ADDENDUM NO. #0

TRACK & FIELD IMPROVEMENTS

LITTLE JOB #612-12353-06

Oxnard High School

C3.2

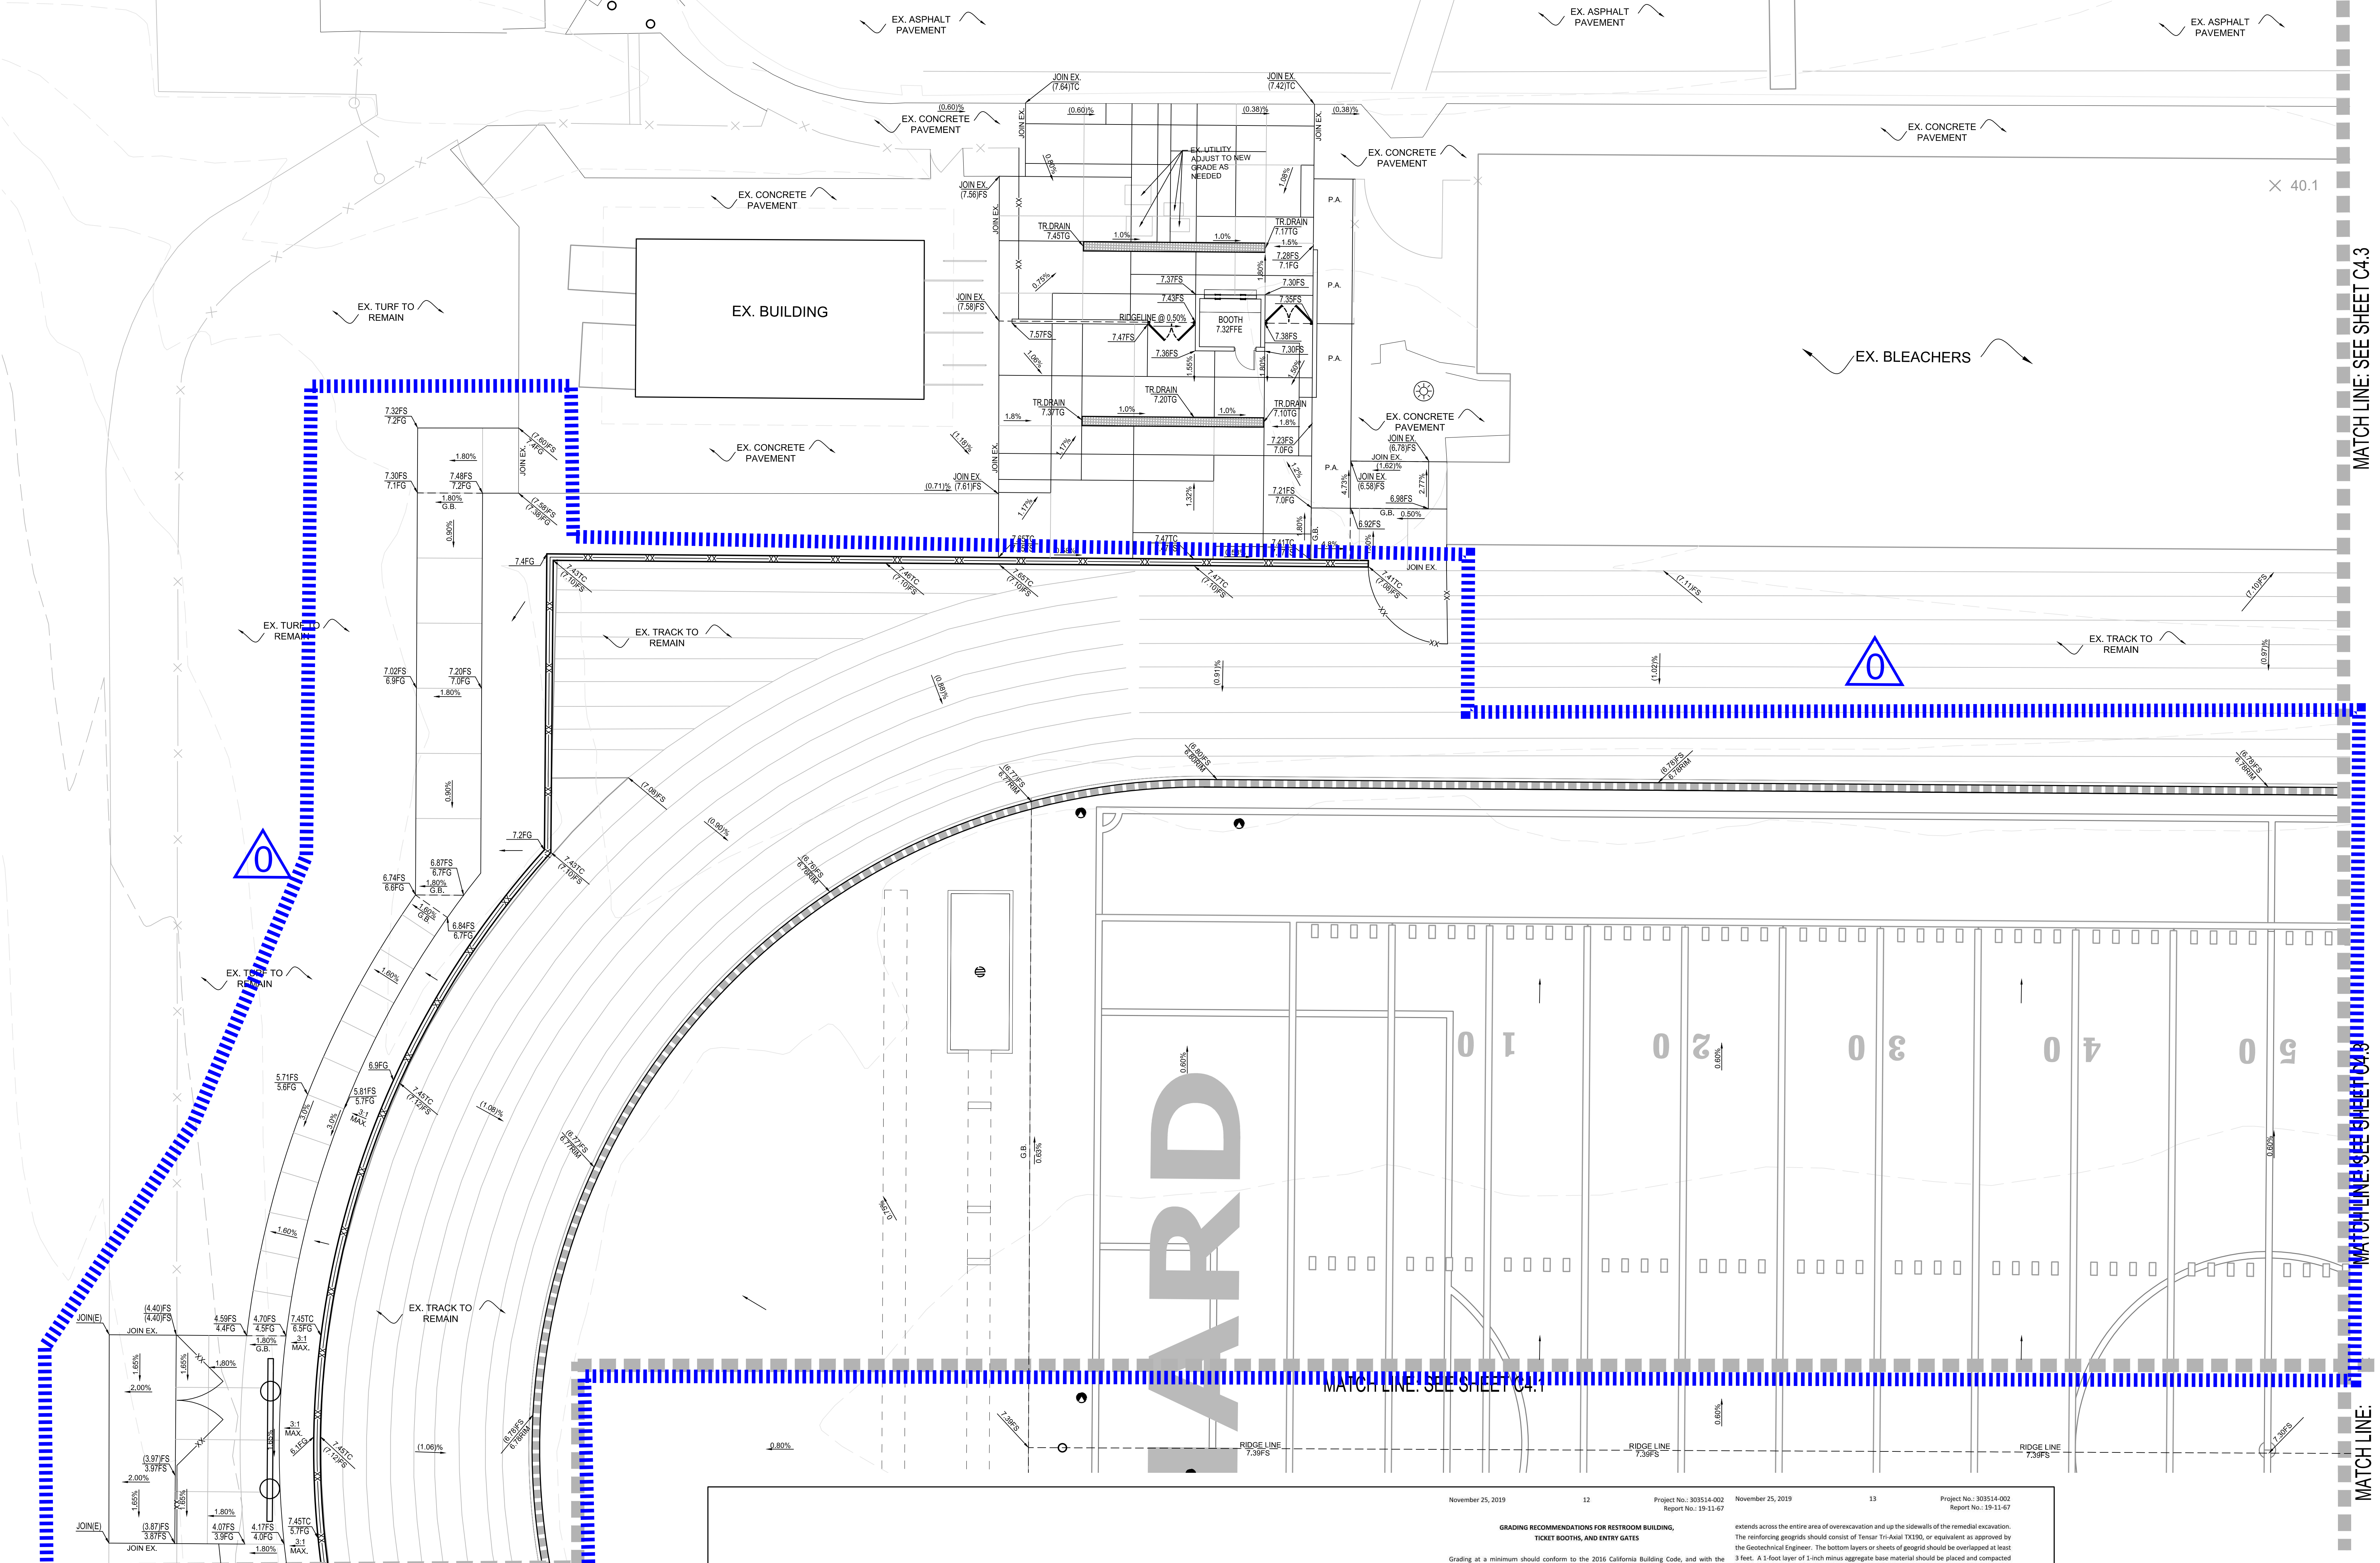
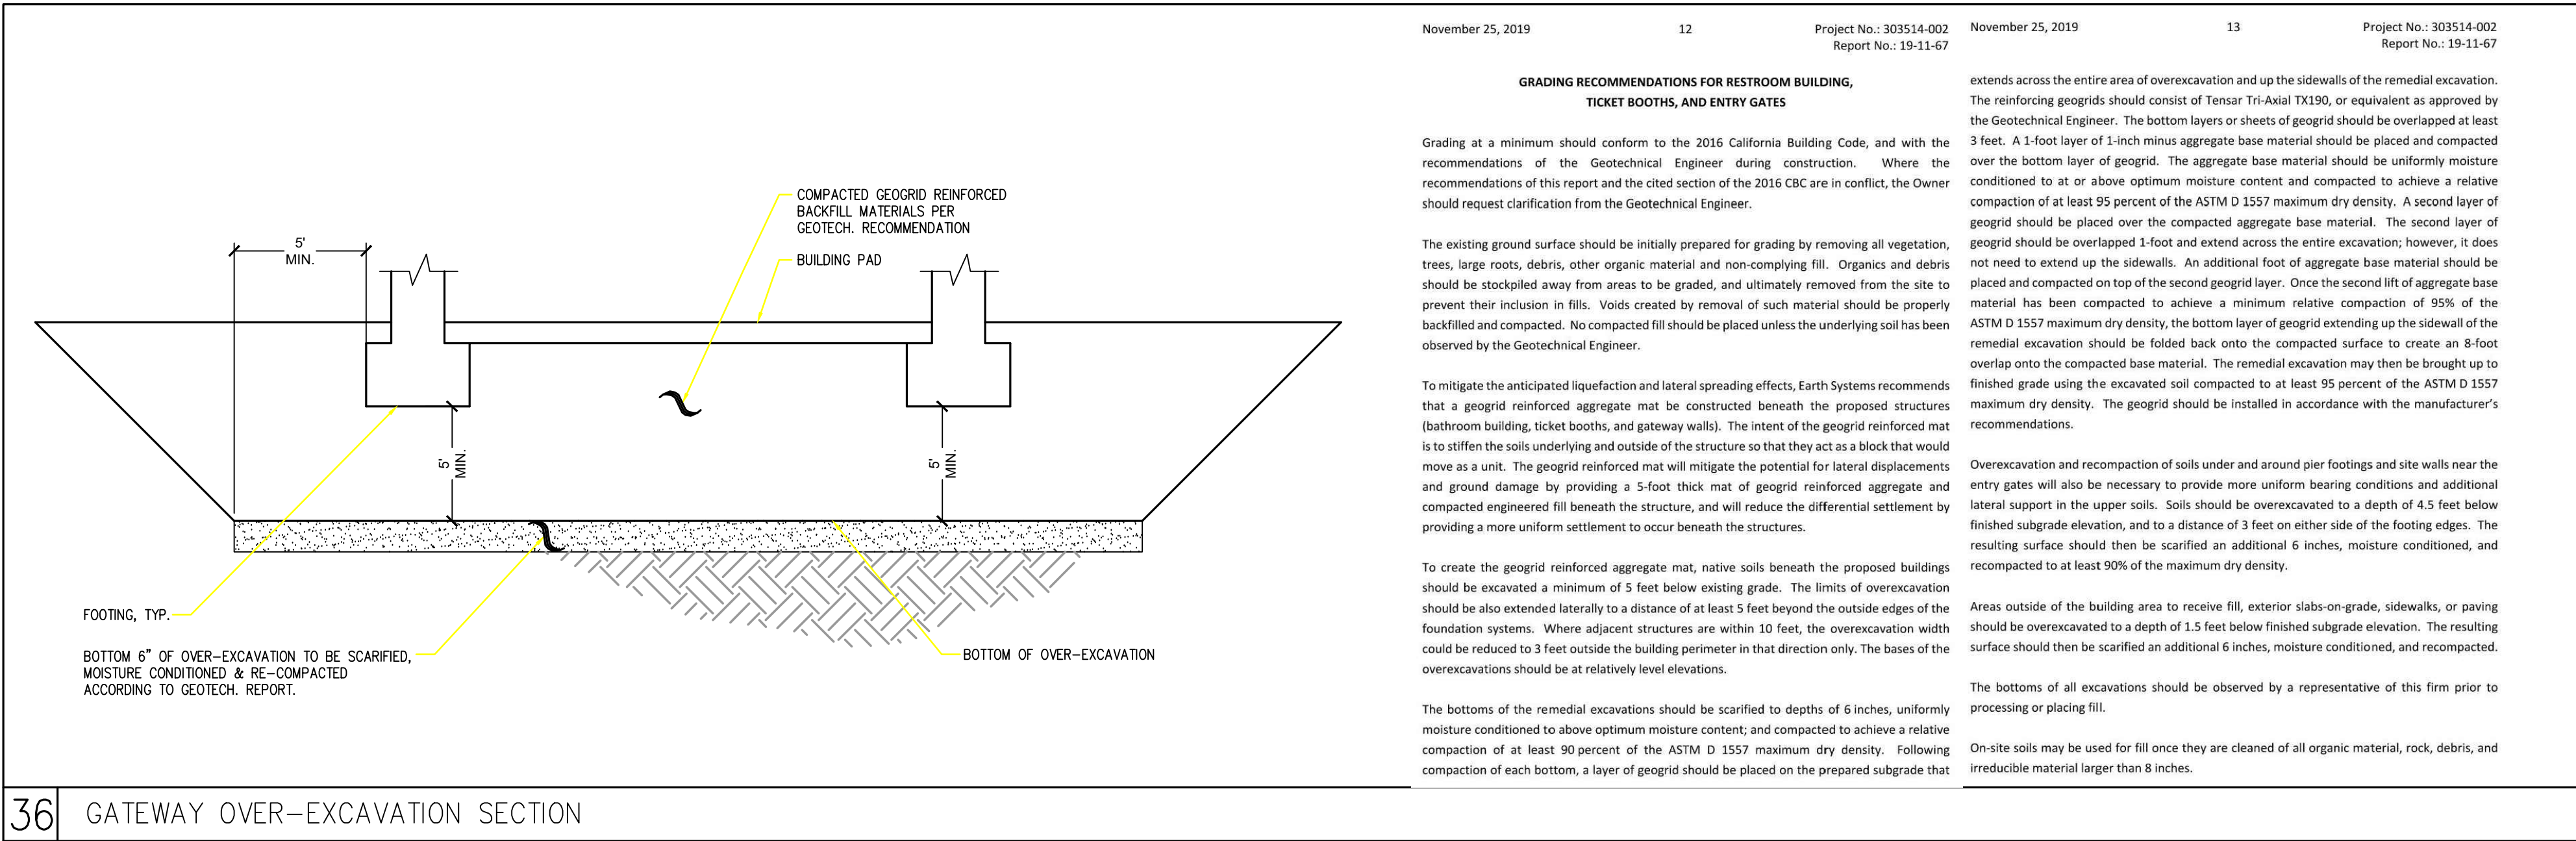
- 3.1.2.5.** Drawing C3.2/AD0-C5 - Only work within outlined area is included in scope of this project and bid. Any work shown outside of the delineated area is not part of this project. Also, we have included a note on plan requiring contractor to gently transition from new improvements tying back to existing improvements via transitional AC paving (3" thick). Directional slopes shall not exceed 4.9% and also cross slopes shall not exceed 1.8%.

furnish and install temporary transitional AC paving (3" thick) to tie into existing surrounding improvements. (directional slope 4.9% max and cross slope 1.8% max)

SHEET NUMBER
C4.0

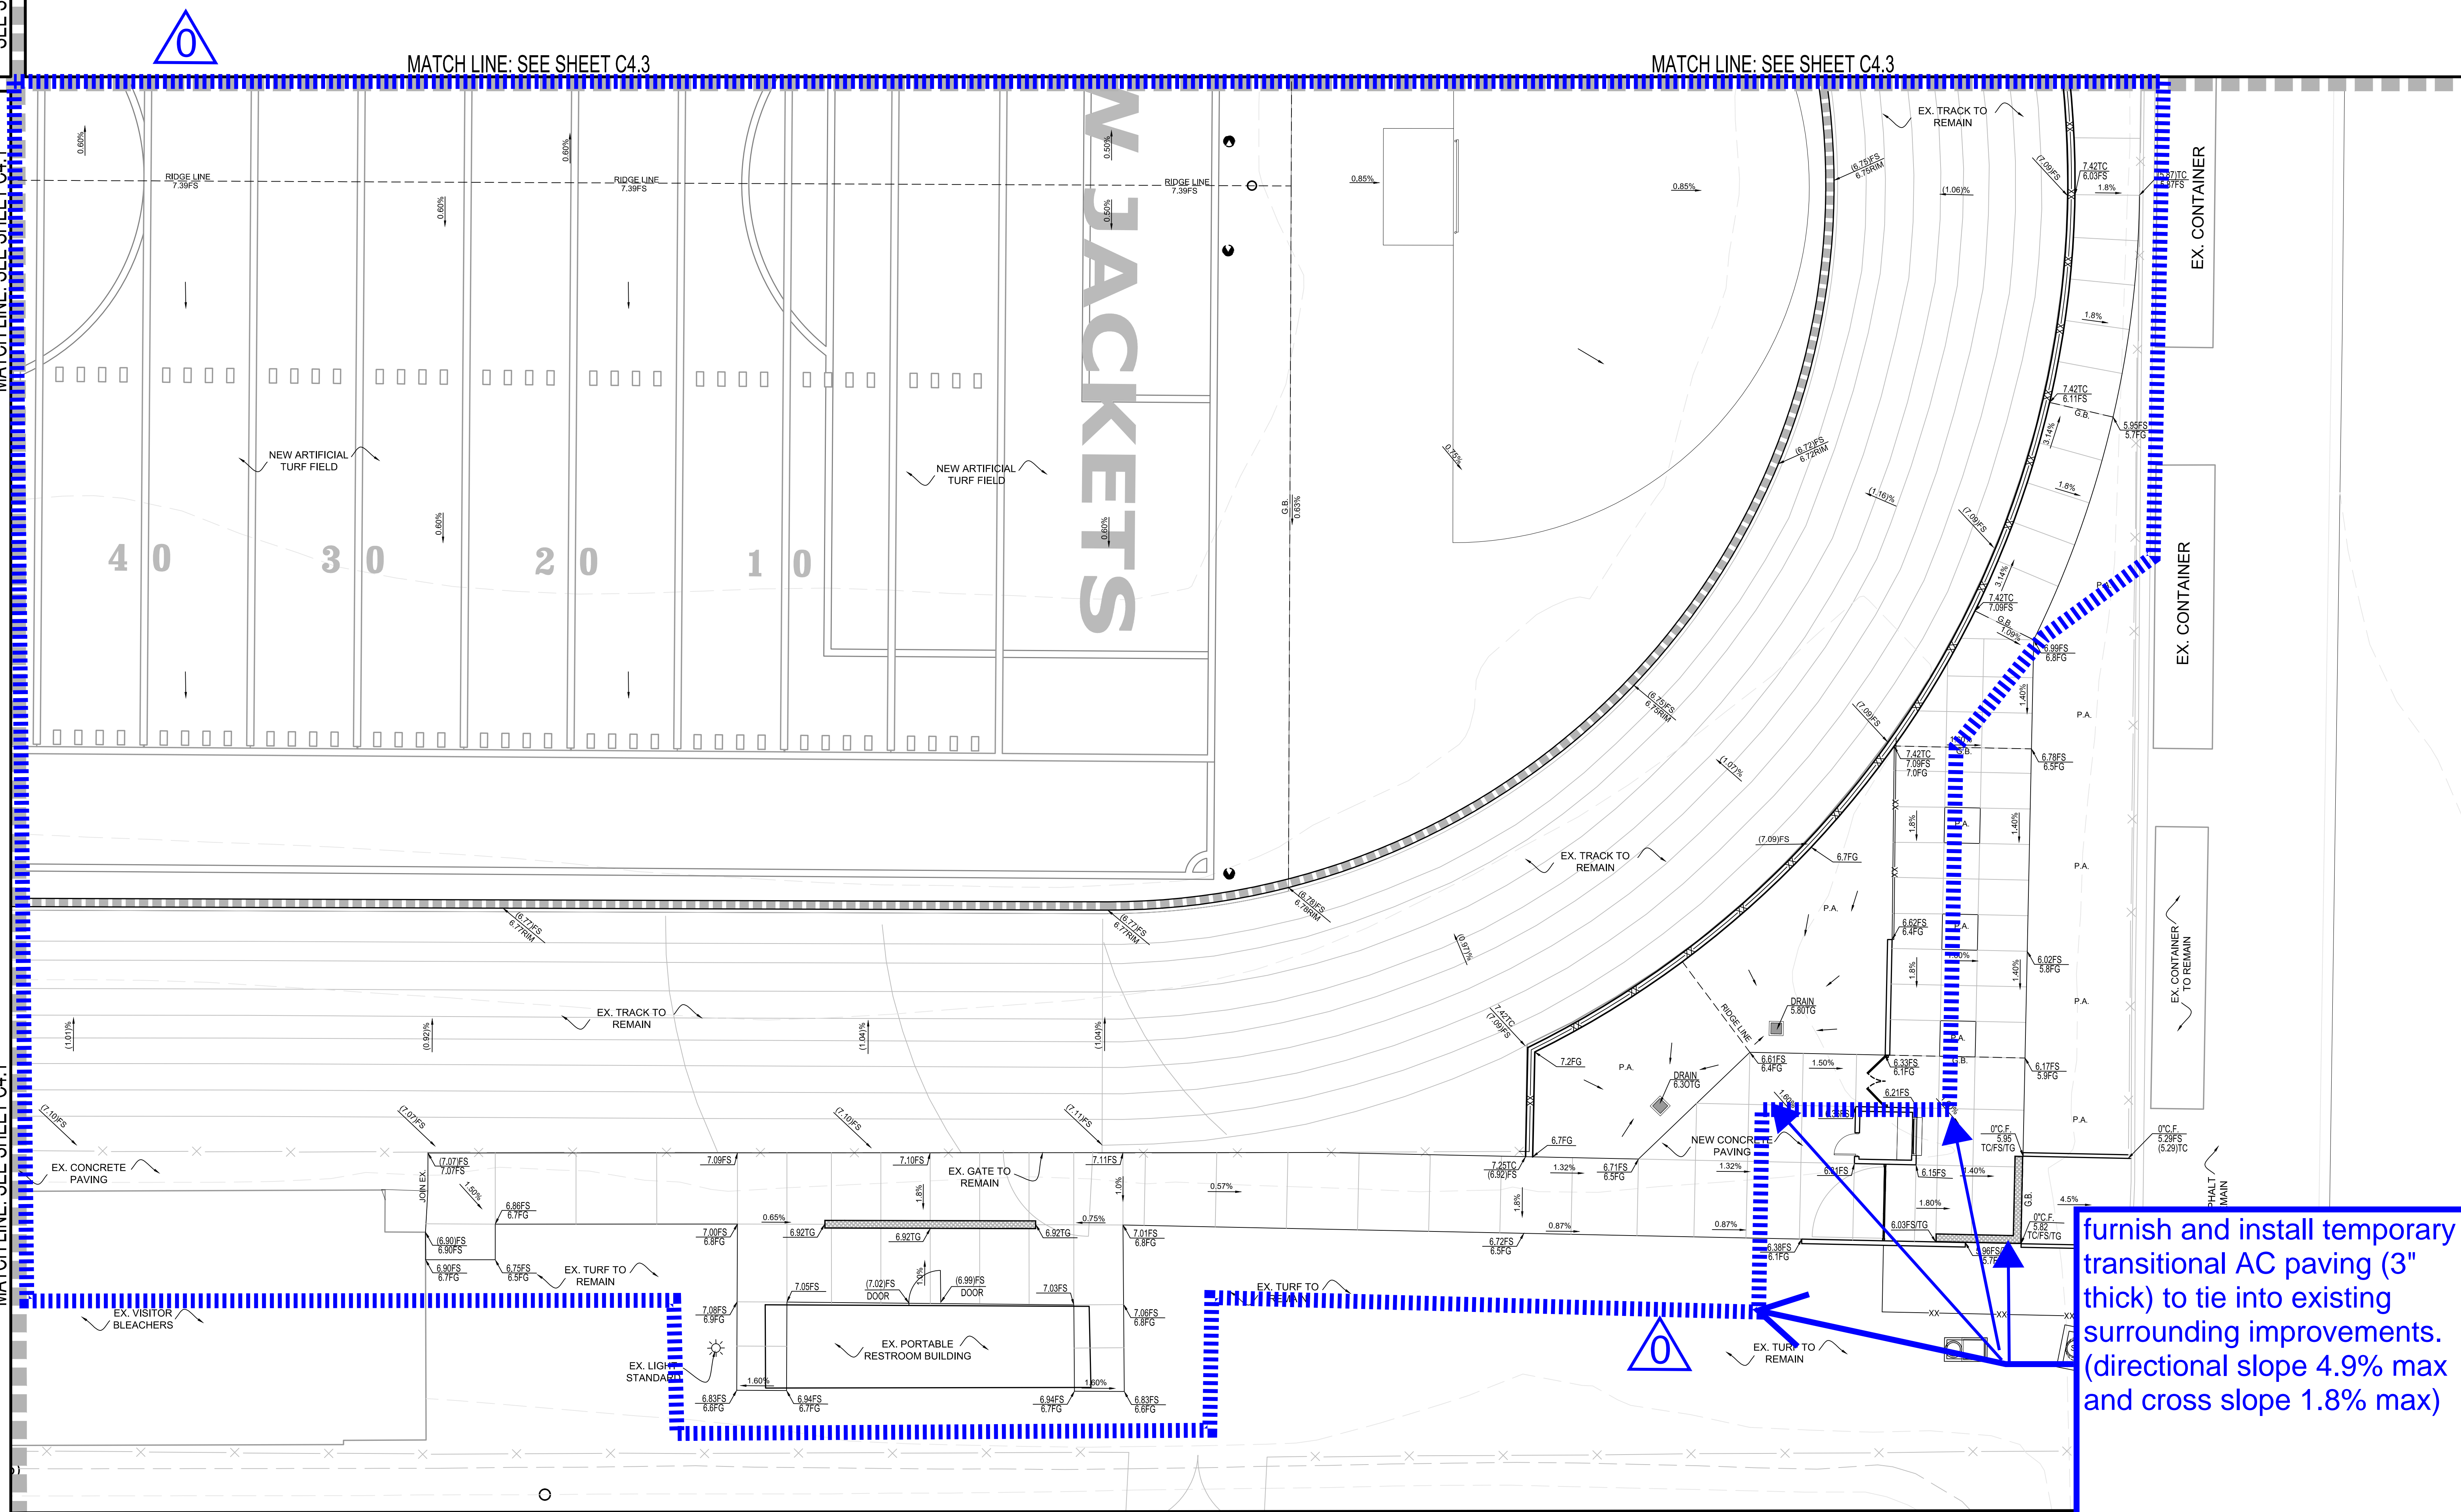
- 3.1.2.7.** Drawing C4.0/AD0-C7 - Only work within outlined area is included in scope of this project and bid. Any work shown outside of the delineated area is not part of this project.
